28F008SC

SPECIFICATION UPDATE

Release Date: February 1997

Order Number 297729-004

Successive Read Operations That Have Long CE#-High Pulse Widths

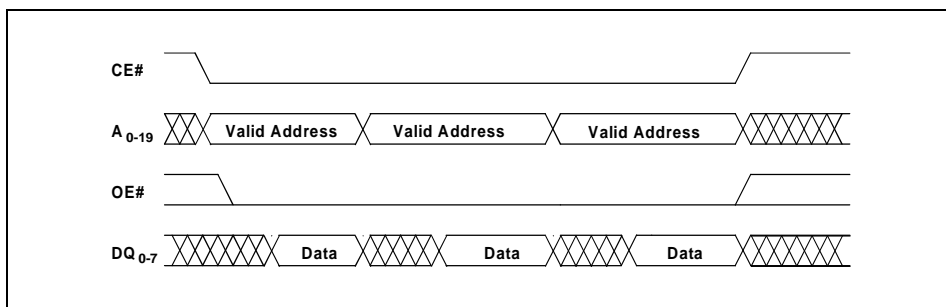
PROBLEM: The component may return invalid data if more than fifteen successive read operations are performed where CE# is deasserted between each read and the corresponding CE#-high pulse width resides within the specifications outlined in the table below.

IMPLICATION: This erratum only affects 2.7V and 3.3V V_{CC} read operations. For these low voltage systems, the usage of the flash memory will affect the exposure to this anomaly. Systems that execute code directly out of the flash memory will be less susceptible to the problem because the flash memory is continuously being accessed for information at a fast rate. In which case, CE# may be driven active while only the address changes to retrieve subsequent data from the component (see below figure, *Access The Flash With CE# Active*) or the CE#-high time will be very short (less than 100 ns) to maximize read throughput. If it is determined that your applications accesses the flash memory in this manner, you will not have problem with this erratum.

1. Read more than four good reads for A-1 and A-3 stepping and only one read for A-6 stepping during each assertion of CE# as illustrated in the figure above.

A Long Series of CE# Glitches May Induce an Invalid Read

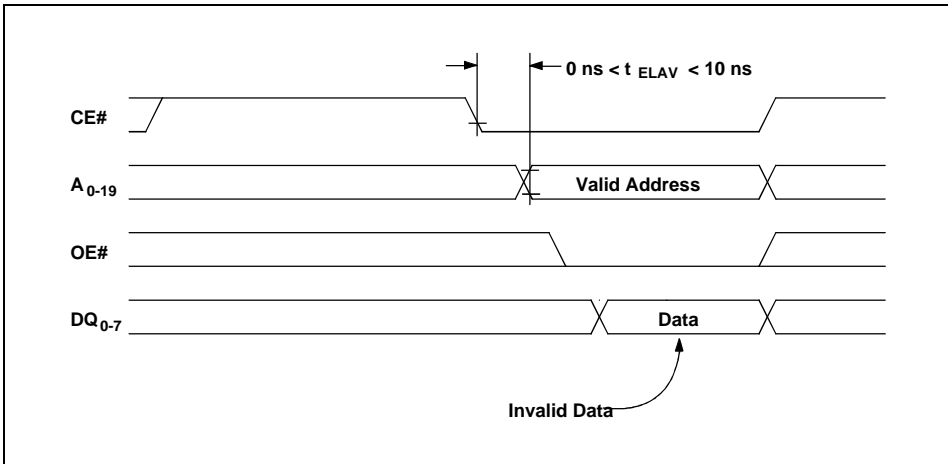
PROBLEM: A noisy CE# control signal may cause an invalid read. This erroneous read only occurs after the device has received over one hundred consecutive short CE# glitches ($t_{EHL} < 65\text{ ns}$) with intermittent CE#-high time (t_{EHL}) greater than 145 ns (see the figure below, *A Long Series of CE# Glitches May Induce an Invalid Read*).

After valid data is read, the device must receive another series of CE# glitches (over one hundred) to induce an invalid read. CE# glitches sequences, other than defined in the figure above, have no adverse effect.

Add system logic to prevent CE# glitches such as latched CE# control logic or pullup/pulldown resistors to the address bus.

If the device receives over one hundred consecutive CE# glitches, issue a Byte Write command and program FFh to any location before executing a read operation. Programming FFh will not alter stored data, but it will give the component sufficient time to prepare for the read operation.

Switching Address Lines after CE#-Low may Cause an Invalid Read

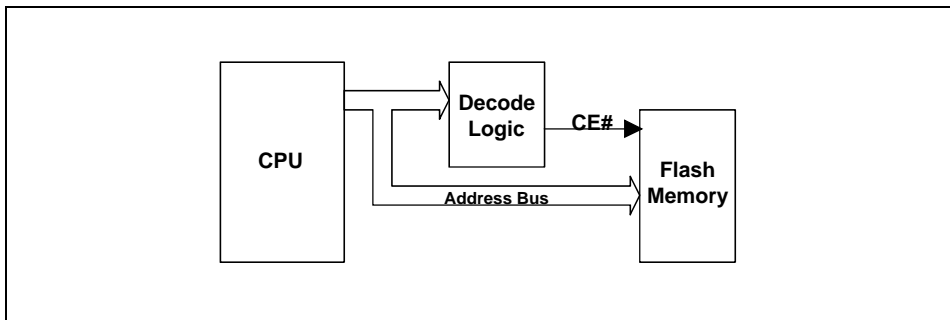
PROBLEM: If an address line transition occurs 0 ns to 10 ns after CE# goes low, the component may return invalid data. Note, this only effects 5V V_{CC} read operations.

If CE# is held low for longer than 10 ns, the device will output valid data t_{AVQV} after an address transition occurs.

Typical CE# Decoding Scheme That Is Less Susceptible to This Erratum

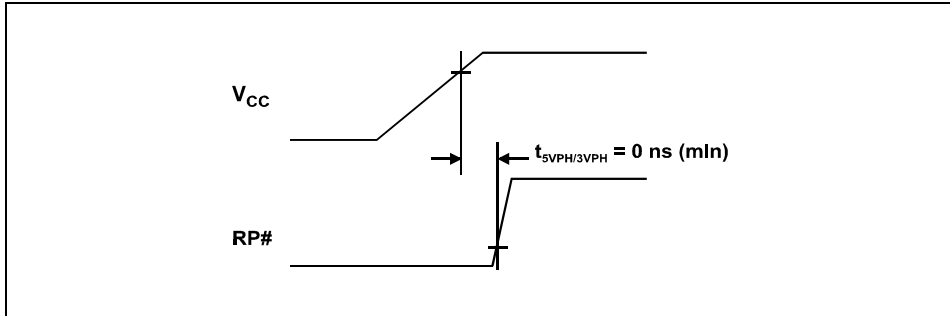
Systems that decode CE# from the CPU's upper address lines will typically provide a valid address prior to asserting CE# (see the figure below, *Typical CE# Decoding Scheme That Is Less Susceptible to this Erratum*). Additionally, applications that access data sequentially will have stable upper address lines. Therefore, CE# will typically remain low when the lower address lines transition to retrieve new data. Systems that execute code from flash memory or download code from flash memory into DRAM will usually access the device sequentially and will therefore be less susceptible to this erratum.

Delay the assertion of CE# until all address lines stabilize. This can be accomplished by adding additional logic or capacitance to delay CE# (maximum CE# slew rate = 10 ns).
